Access Compliance Report

Public Rights-of-Way

(Curb Ramps)

Intersection ID: 10661	Main Street: N_DAVIDSON_ST	Cross Street: E_28TH_ST	Location: E
ADA ID: 42AE73632EC9	Ramp Type: BlendTrans1	Initial Pass/Fail: Fail	Overall Compliance: No
Severity Score: 21.25			
Codes/Mitigation Info/Possible Solution		Field Measurements/Component Compliance

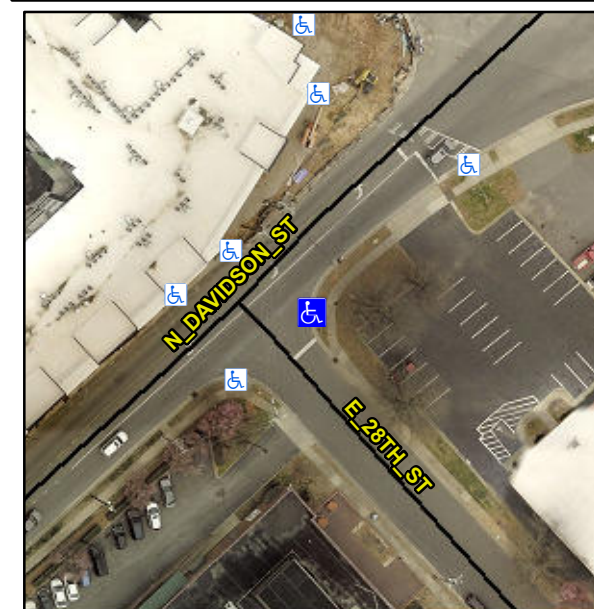
Not Found, R304.5.1, R304.5.3

Compliance	Description	Data	Compliance	Description	Data
N/A	Ramp Length (in)	78.0	Yes	BlendTrans Slope (%)	3.0
No	Ramp Width (in)	37.5	No	BlendTrans XSlope (%)	5.4
N/A	Flare Type LT	N/A	N/A	Flare Type RT	N/A
N/A	Flare Slope LT (%)	N/A	N/A	Flare Slope RT (%)	N/A
N/A	Flare Traversable LT?	N/A	N/A	Flare Traversable RT?	N/A
N/A	Landing Length (in)	N/A	N/A	DWS Provided?	N/A
N/A	Landing Width (in)	N/A	N/A	DWS Contrast?	N/A
N/A	Landing Slope (%)	N/A	N/A	DWS Length (in)	N/A
N/A	Landing X Slope (%)	N/A	N/A	DWS Full Width?	N/A
N/A	Landing Curb? (Y/N)	N/A	N/A	DWS Offset (in)	N/A
N/A	Shared Landing?	N/A			
N/A	Gutter Ponding?	N/A	N/A	Gutter Slope (%)	N/A
N/A	Gutter Lip Ht (in)	N/A	N/A	Gutter X Slope (%)	N/A
N/A	Painted X Walk1?	No	N/A	Painted X Walk2?	No
	X Walk 1 Direction	To NW		X Walk 2 Direction	To SW
	X Walk 1 Width (in)	N/A		X Walk 2 Width (in)	N/A
	X Walk 1 Slope (%)	3.0		X Walk 2 Slope (%)	2.5
	X Walk 1 X Slope (%)	2.9		X Walk 2 X Slope (%)	2.4

N/A	Ramp inside XWalk1?	N/A	N/A	Ramp inside XWalk2?	N/A
	Road Slope (%)	4.9		Clear Space?	N/A
	Road X Slope (%)	1.3	N/A	Clear Space to XWalk (in)	N/A
N/A	Any Obstructions?	N/A	N/A	Storm Grate/Utility Hazard?	N/A
	Obstruction Type			Storm Grate/Utility Type	
		N/A			N/A
			Yes	Surface Condition? (G/P)	Good
			No	Curb Slope (%)	17.4

Remove & Replace Curb Ramp With Two New Directional Ramps or Equivalent.
